MMF TDECQ / SECQ discrepancies and corner cases

Piers Dawe

*New material about transition time on slides 6 and 7 (D1.1 comments 8 and 9)
New material about over-emphasis on slides 6 and 8 (D1.1 comments 5 and 6)*

TDECQ or SECQ vs. transition time

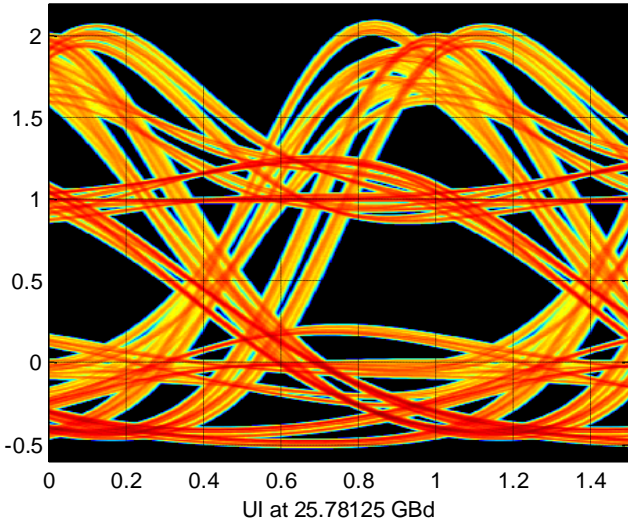
29 to 30 ps for 150 m MMF **Comment 8: This limit should be tightened, or the transition time measured in the same bandwidth as TDECQ**

If the transition times were measured in the same bandwidth as the associated TDECQ, the lines would be close to each other, where the red line is

Example over-emphasised signal (top left green stars on slide 6)

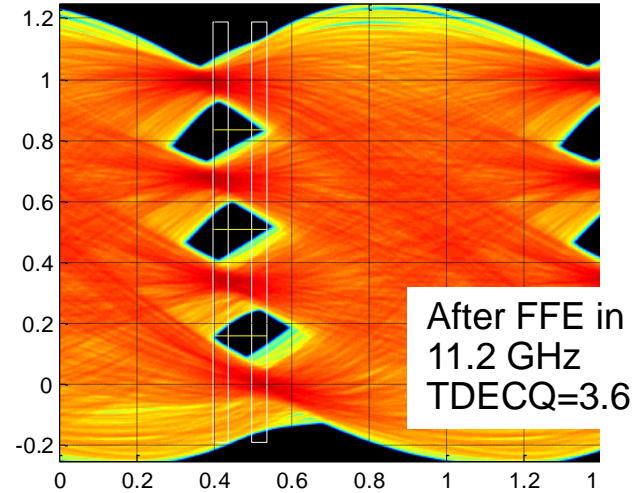
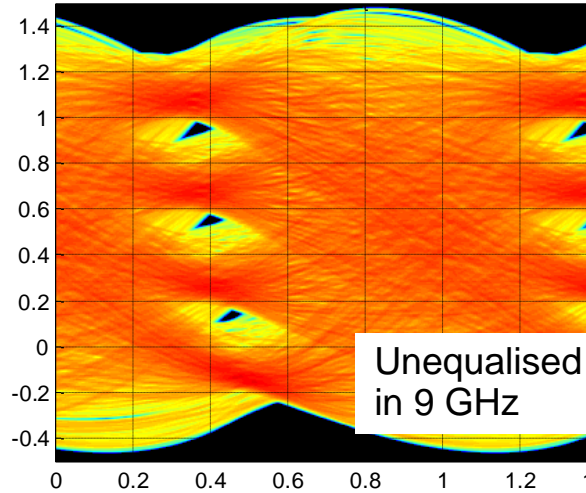
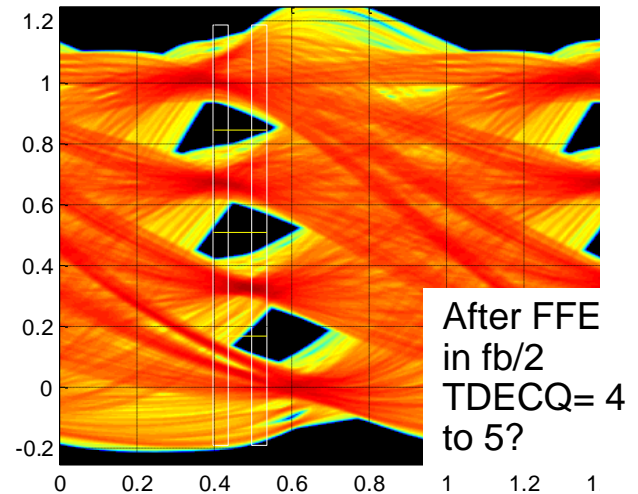
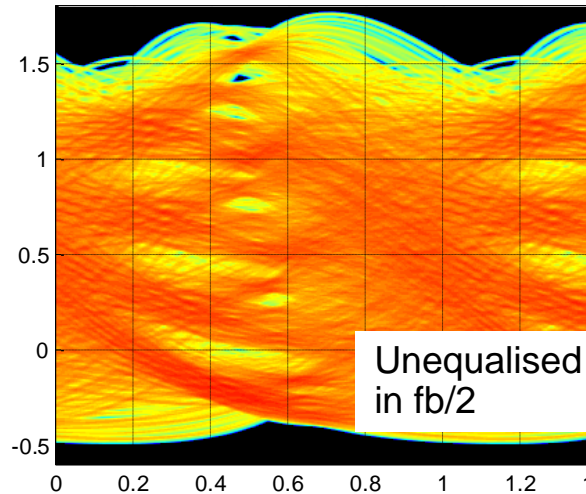
- Top left: transmitter with PAM2 signal
- 0 and 1 are OMA's zeros and threes
- Note different y scales
- This over-emphasised signal benefits from the low bandwidth in MMF TDECQ
- Fails back-to-back

Should either measure TDECQ in fb/s as well as 11.2 or 9 GHz, or increase minimum cursor tap, or both
